## SERVICE BULLETIN

#0023

**SUBJECT:** Incorrect Nose Gear Bolt Replacement

Figure 1: Correct Nose Gear Bolt thread length

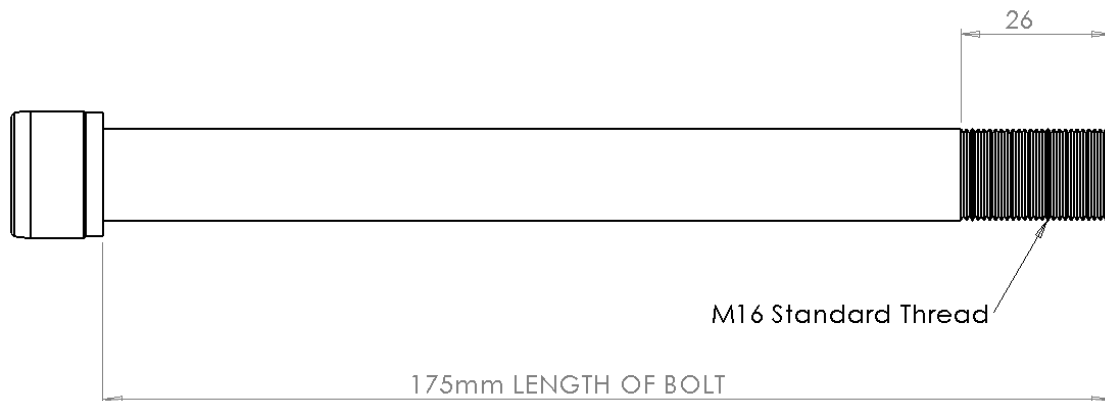
The threaded section on the nose gear bolt provided to the affected aircraft is too long. This results in the threaded section of the bolt being loaded and may make the bolt more likely to fatigue and/or possibly break with a rough landing. This bolt needs to be replaced with one of the correct thread length to ensure that the thread does not get loaded.

Figure 1 shows the correct nose gear bolt dimensions. The nose gear bolt (HW-MCB-612-X-X-0) dimensions should be checked and if the bolt's thread length is incorrect it must be replaced with a new bolt of the correct dimensions. These bolts can be ordered from Sling Aircraft.

Figure 4: Nose gear wheel assembly

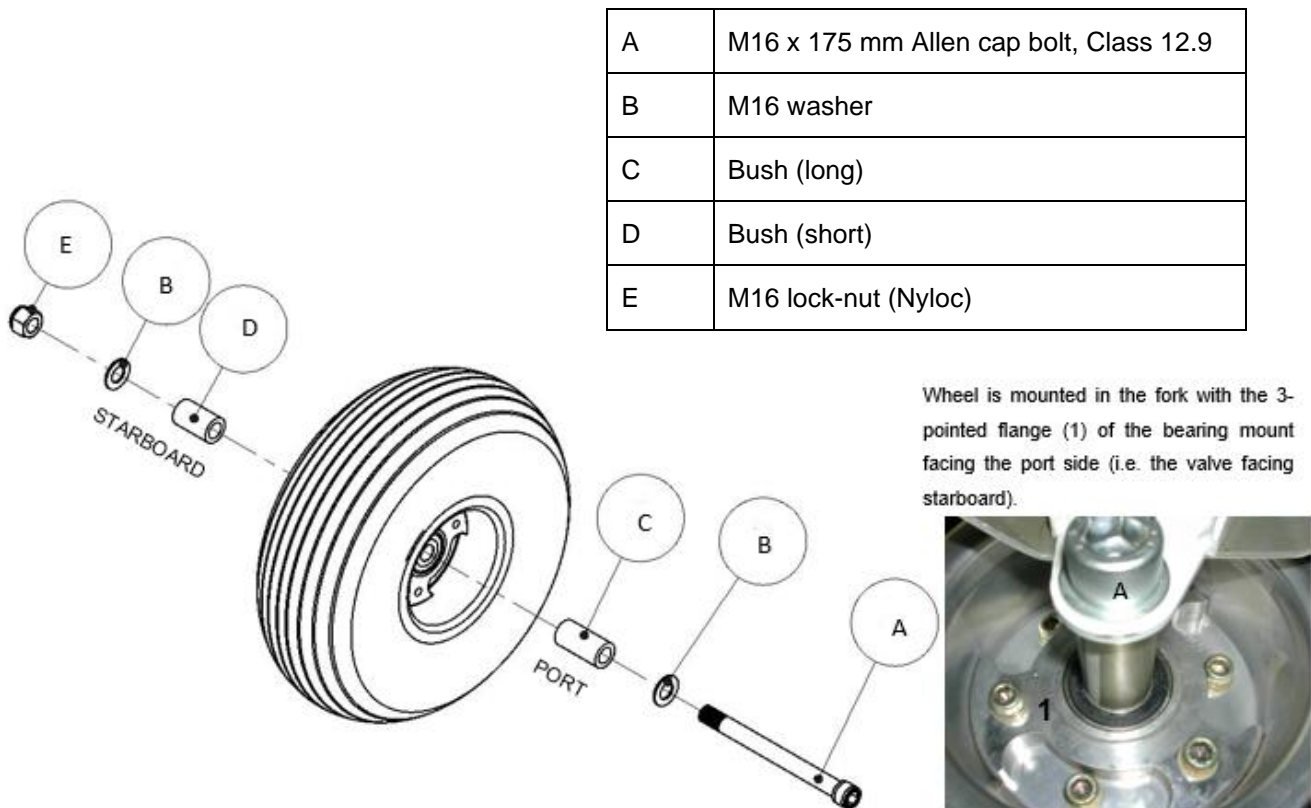
Step 1: In order to install the new replacement bolt with the correct thread length, reverse the procedure specified in Section 3.1. Ensure that the assembly of the wheel get reassembled correctly. Refer to the exploded view of the wheel axle assembly to ensure the components get placed in the correct positions, refer to Figure 4.

- Step 2: Torque the M10 Allen cap bolt to 10.5 Nm.
- Step 3: Apply torque seal into the bolt.
- Step 4: Verify free rotation for the wheel.
- Step 5: Apply Loctite 222 to the failing screws and reinstall the nose gear fairing.
